**Responses to Public Comments
Submitted on the Draft Regulatory Guide
for Evaluation of Electromagnetic and
Radio-Frequency Interference in Safety-
Related I&C Systems
(DG-1029)**

September, 1998

**U.S. NUCLEAR REGULATORY COMMISSION
OFFICE OF NUCLEAR REGULATORY RESEARCH
Division of Systems Technology
Control, Instrumentation, and Human Factors Branch**

Figure 7 Comparison of low-frequency radiated emissions envelopes

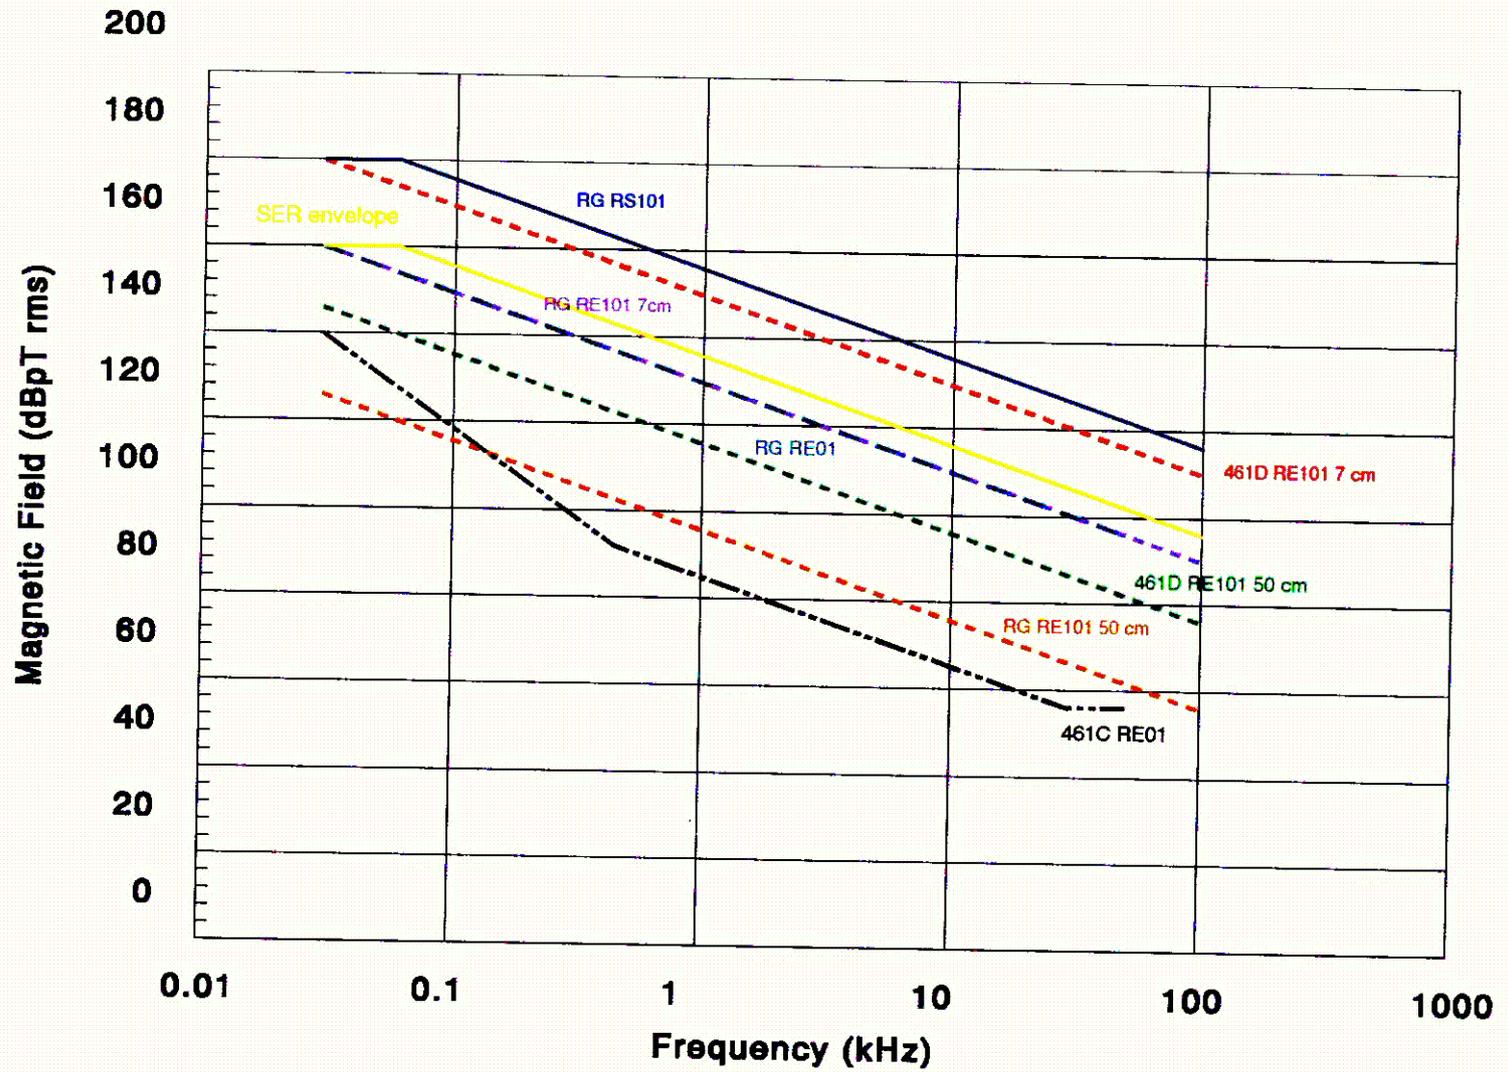
Figure 7 provides a comparative plot of the RG (i.e., DG-1029) envelopes for RE101, RE01, and RS101, the baseline MIL-STD envelopes, and the corresponding envelope endorsed by the SER on EPRI TR-102323. It is seen that the RG for emissions measured at a distance of 7 cm from the equipment and SER envelopes are similar in level. The RG envelope for emissions measured at a distance of 50 cm from the equipment provides an alternate envelope for area emissions control.

Figure 8 Comparison of high-frequency radiated emissions envelopes

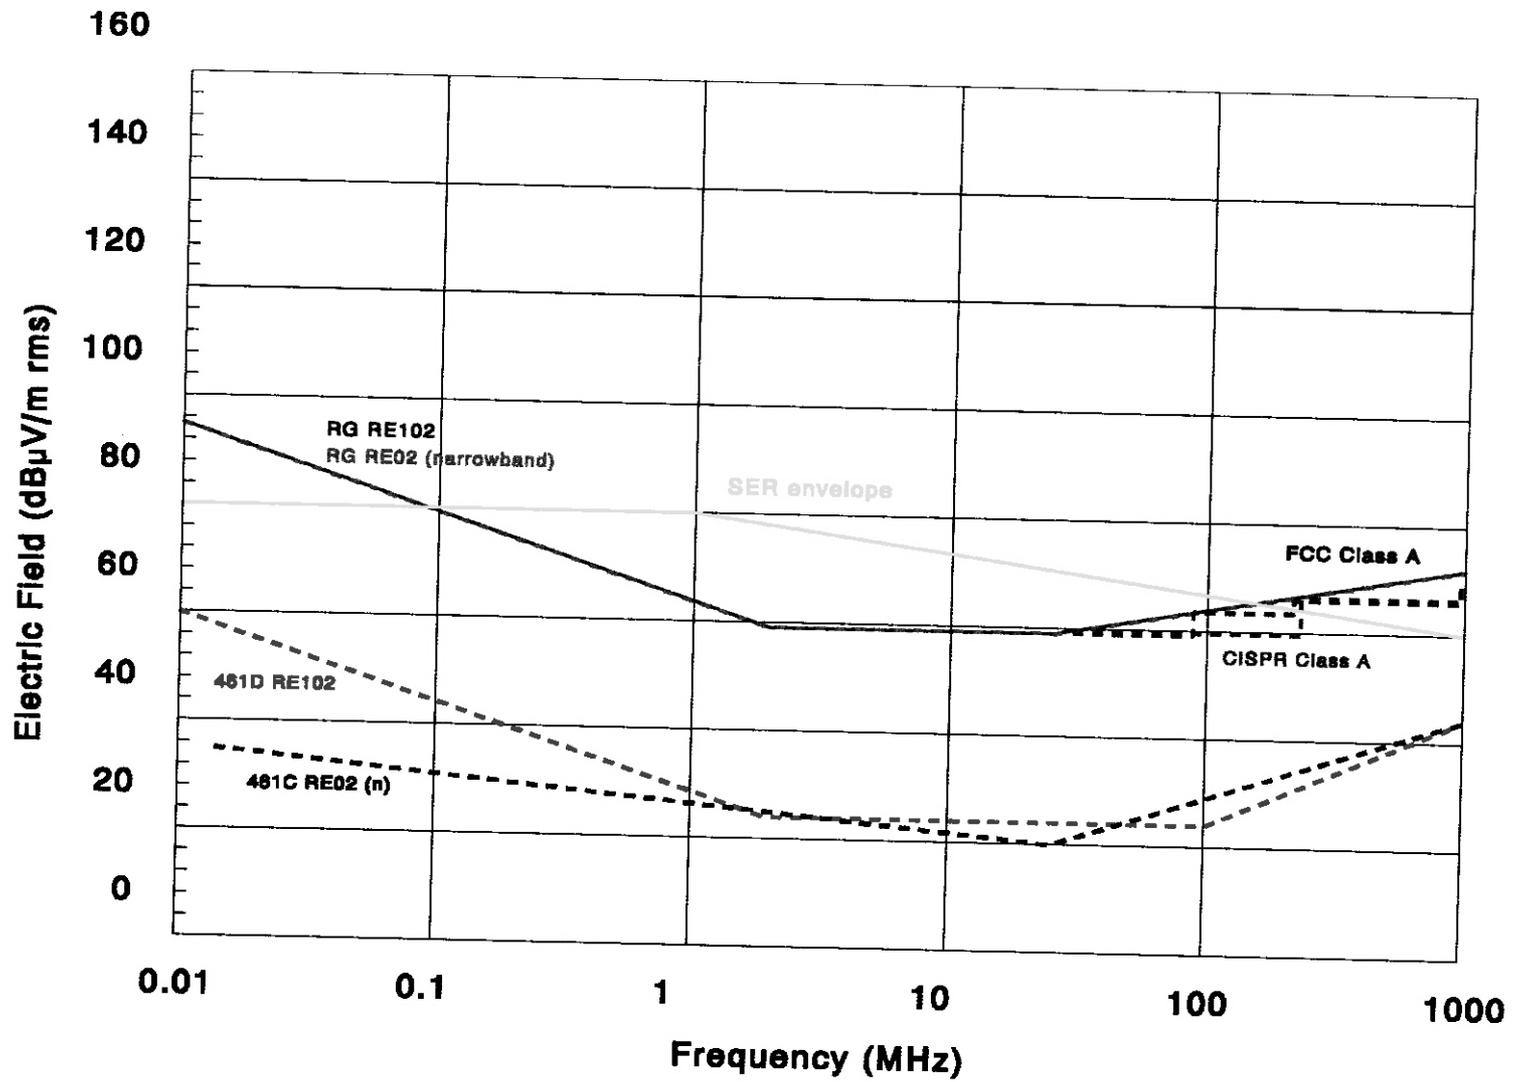
Figure 8 provides a comparative plot of the RG (i.e., DG-1029) envelopes for RE102 and RE02, the baseline MIL-STD envelopes, the corresponding envelope endorsed by the SER on EPRI TR-102323, and the Class A equipment emissions limits for CISPR and

Figure 4.1 CE101 Emissions Envelope for dc Power Leads

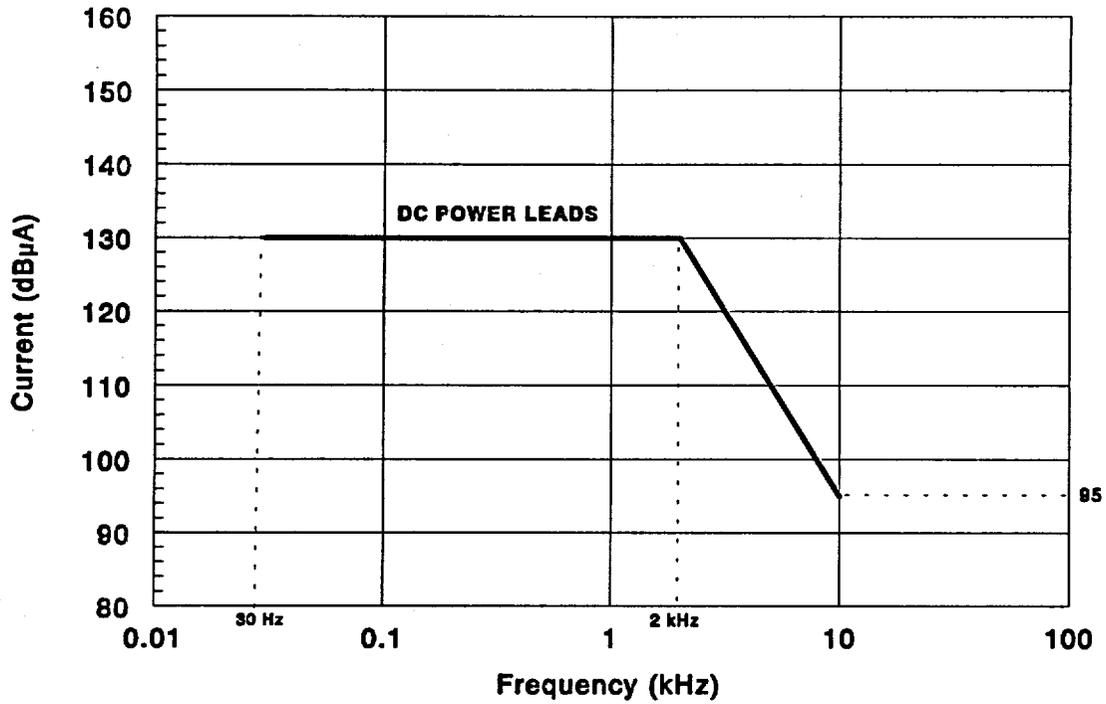
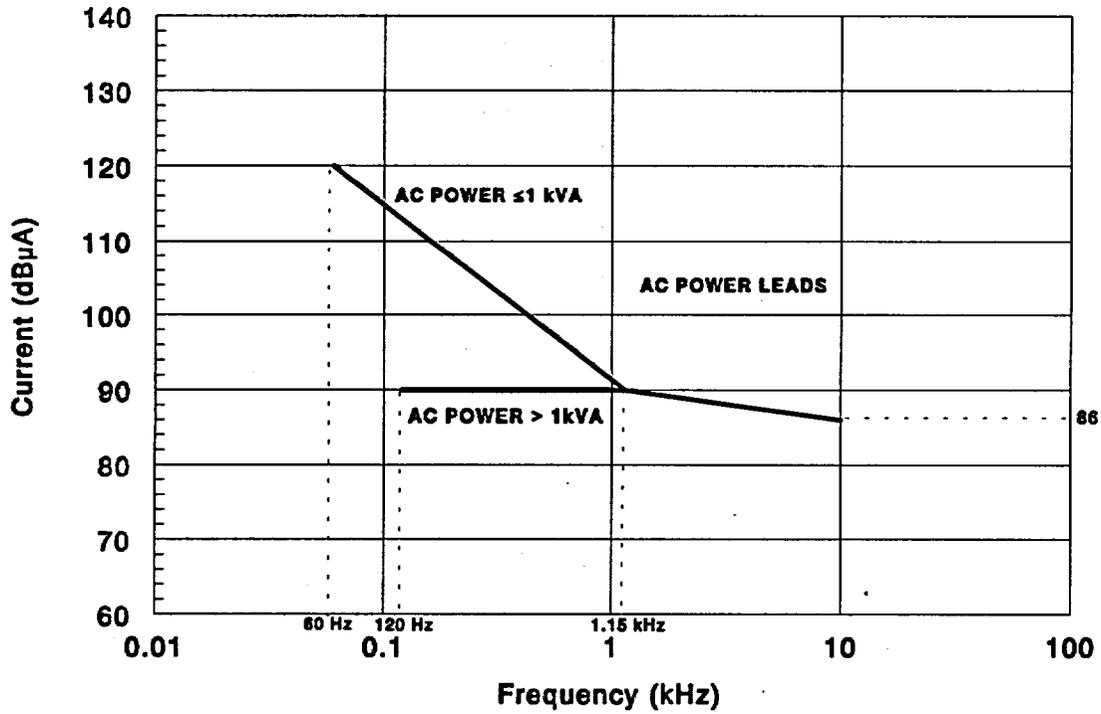
The limits set in Figure 4-1 are 32 dB μ A more restrictive than the TR-102323-R1 guidelines for the ac leads and 8 dB μ A less restrictive for the dc leads. Further, these levels are inconsistent with the guidance in MIL-STD 461D, which really only apply to Army and Navy aircraft and Navy ships and submarines. Further, Figure 4-1 does not give any guidance for variations due to consumption power level. The result is that a device drawing 500 milliamperes ac power (114 dB μ A at 60 Hz) could never pass this test. Suggest this paragraph and figure be revised to be more in line with the TR-102323-R1. <10>

The emissions limit for AC Power Leads is excessively restrictive compared to other standards. No justification is provided for deviation from the less restrictive equipment emissions limits previously endorsed for low-frequency conducted equipment emissions, via EPRI TR-102323 and the newly established limits from MIL-STD 461D. For an endorsement of MIL-STD 461D emissions limits, Figure CE101-4 for source voltages above 28V would be more appropriate and not compromise the adequate safety margin.

The CE101 emission limits given in MIL-STD 461D are different than those shown in Figure 4.1. The values given in Figure 4.1 are based on the limits given in CE01 of 461C. An example of mixing two different sets of requirements-see statement in regulatory position C.3 that specifies no mixing and matching of test criteria. <106>

The figure illustrating the CE101 (conducted emissions, power leads, low frequency) operating envelopes will be replaced by two figures showing the operating envelope for dc power leads and the modified operating envelopes for ac power leads (see attached figures). Thus Figure 4.1 becomes Figures 4.1 and 4.2.

Figure 4.3 CE102 Emissions Envelopes

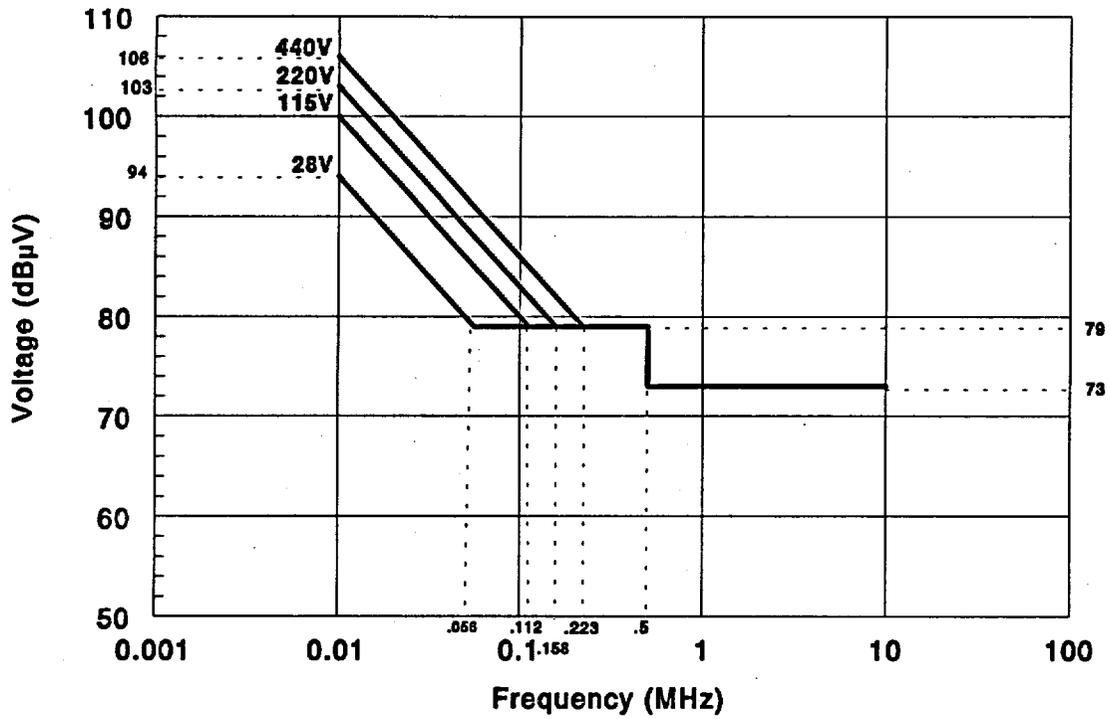
The limits in Figure 4.2 are extracted directly from MIL-STD 461D and are specified in terms of $\text{dB}\mu\text{V}$ while all of the survey data in TR-102323-R1 and NUREG/CR-6431 was measured in terms of $\text{dB}\mu\text{A}$. If one takes the starting point for the 115V limit at 10 kHz ($100 \text{ dB}\mu\text{V}$) and converts this to current on a 50 ohm line, this equates to $66 \text{ dB}\mu\text{A}$ and this point is discontinuous (by $21 \text{ dB}\mu\text{A}$) with the ending point from the limit for an ac line in paragraph 4.1. The uncertainty of actual line impedance at the point of measurement applies equally to both current and voltage measurement. However, the difficulty in making a voltage measurement was demonstrated in the site survey data by both EPRI and Oak Ridge. Clearly, voltage measurements are not practical and considerable site emission data exists in terms of current.

The figure illustrating the CE102 (conducted emissions, power leads, high frequency) operating envelopes will be replaced by a new figure showing the modified operating envelopes (see attached figure). Also, Figure 4.2 becomes Figure 4.3.

Figure 4.4 CS101 Operating Envelopes

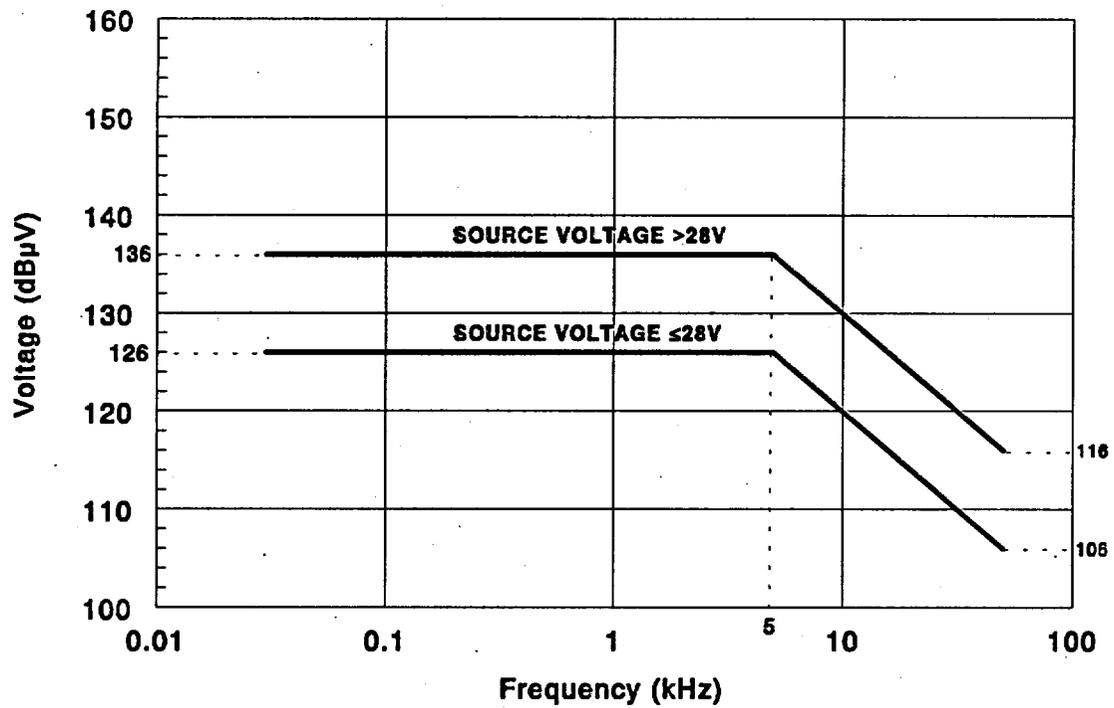
The end point shown in Figure 4.3 as 127 dB at approximately 50 kHz does not agree with the end point shown in Figure CS101-1 in 461D (116 dB at 50 kHz). <107>

The figure illustrating the CS101 (conducted susceptibility, power leads, low frequency) operating envelopes will be replaced by a new figure showing the modified operating envelopes (see attached figure). Also, Figure 4.3 becomes Figure 4.4.

Figure 4.6 RE101 Magnetic Field Emissions Envelopes

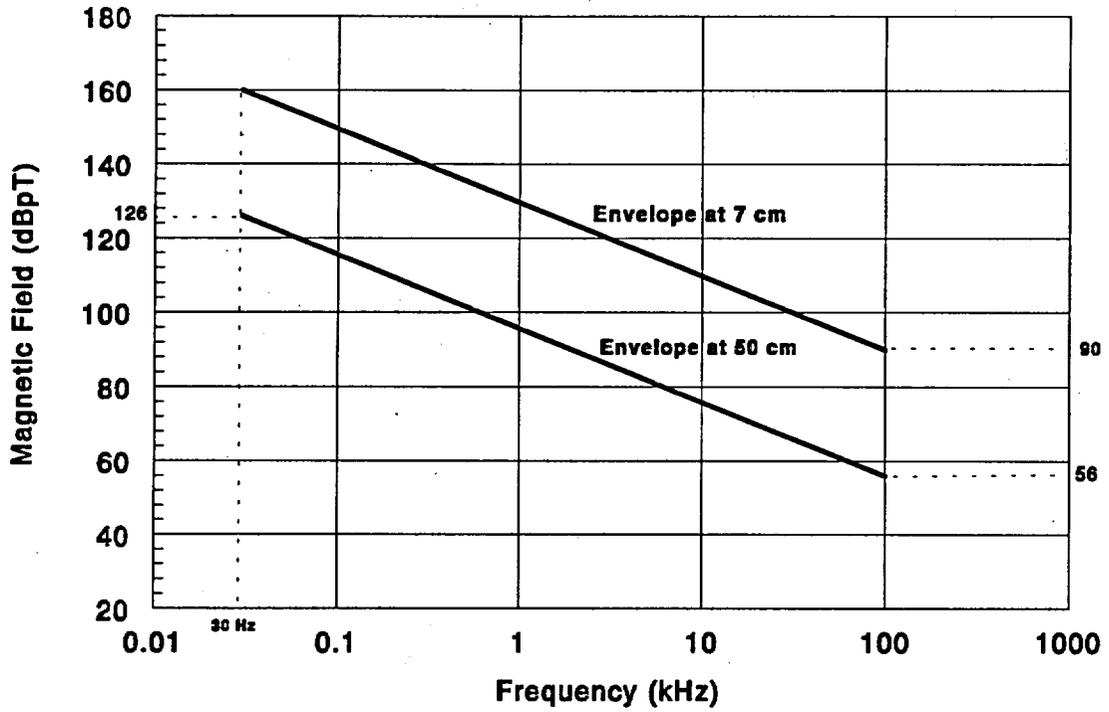
First, dealing only with the 7 cm envelopes, the curve from Figure 4.5 is 30 dBpT more restrictive than the curve from the MIL-STD 461D, Figure RE101-2 and 10 dBpT more restrictive than the limit from TR-102323-R1, Figure 7-3. A reasonable compromise would be to defer to the 7cm curve in Figure RE101-2 from the MIL-STD 461D. <15>

The suggestion here is to adopt the limit from Figure RE101-2, MIL-STD 461D for 7 cm and eliminate the limit for 50 cm. <16>

Figure 4.5 limits do not agree with RE101-1 or RE101-2 of 461D or Figure 6-13 (RE01) of 461C. <109>

<15> The emissions envelopes for radiated magnetic fields will be modified to correct an error in establishing the appropriate levels. The envelope given in Figure RE101-2 of MIL-

The figure illustrating the RE101 (radiated emissions, magnetic field, low frequency) operating envelopes will be replaced by a new figure showing the modified operating envelopes (see attached figure). Also, Figure 4.5 becomes Figure 4.6.

Figure 4.7 RE102 Emissions Envelope

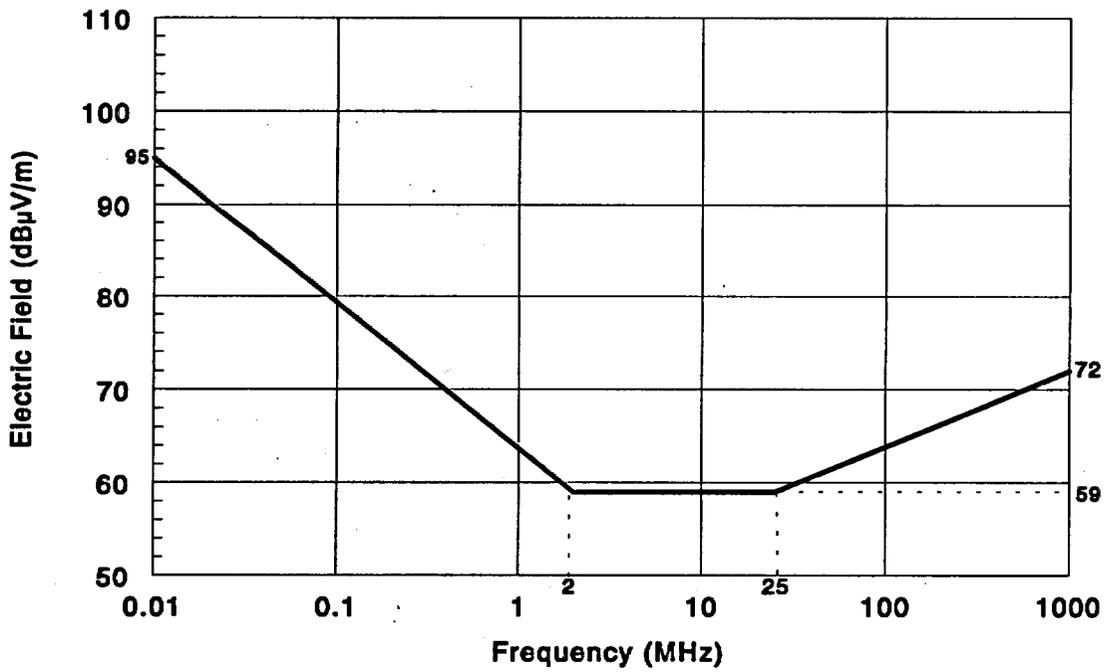
The emission limits in Figure 4.6 appear to be taken from MIL-STD 461D, RE102-2 and were meant to apply to aircraft and space system applications. At 1 MHz, these limits, at 24 dB μ V/m, are 50 dB μ V/m more restrictive than the limits in TR-102323-R1, Figure 7-4. The survey data reported in NUREG/CR-6431, Table 6.2, indicate the highest observations are in excess of 107 dB μ V/m. The TR-102323-R1 closely matches the FCC Part 18 Industrial Scientific and Medical Emission guidelines. The Figure 4.6 emission limits do not appear to be based on either the ORNL experience or the EPRI experience and would result in unreasonable requirements for equipment manufacturers.

The original RE102 operating envelope presented in DG-1029 was based on Fig. RE102-3 in MIL-STD 461D. The envelope for Army ground applications was selected. The envelope was extended below 2 MHz to provide complete coverage of the frequency range corresponding to the test method. The basis for the envelope from 10 kHz to 2 MHz is a relationship with CE102 (conducted emissions, power leads, high frequency), which addresses power quality issues [MIL-STD 461D App., p. A-25]. Thus, the emissions envelope was continuous over the frequency range corresponding to the test criteria in DG-1029 and provided consistent coverage compared to RE02 (radiated emissions, electric field, high frequency). Use of the restrictive Army emissions envelope was justified because the site survey data for electric fields, reported in NUREG/CR-6436, closely approach the 8 dB margin band below the RS103 (radiated susceptibility, electric field, high frequency) operating envelope. Therefore, close control of radiated electric field emissions seemed justified.

The figure illustrating the RE102 (radiated emissions, electric field, high frequency) operating envelopes will be replaced by a new figure showing the modified operating envelopes (see attached figure). Also, Figure 4.6 becomes Figure 4.7.
